**RULE NO.: R161-22.12**

## NOTICE OF RULE ADOPTION

R161-22.12: Proposed revision to Standards 512-AW-01, 512-AW-02, and 520S-17

# Rule 1 - Standards 512-AW-01, 512-AW-02, and 520S-17

STANDARD NO. 512-AW-01 1 OF 1

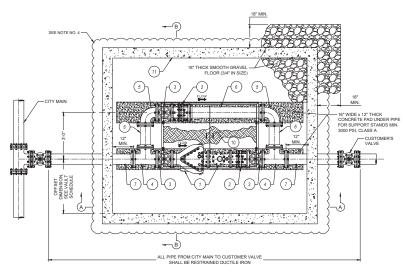
- 1. Standard 512-AW-01 Create a new Standard for Dual PRV Stations.
- 2. Standard 512-AW-02 Create a new Standard for Fire Lines Meters.
- 3. Standard 520S-17 Discontinue this Standard as it is being replaced with Standard 512-AW-02.
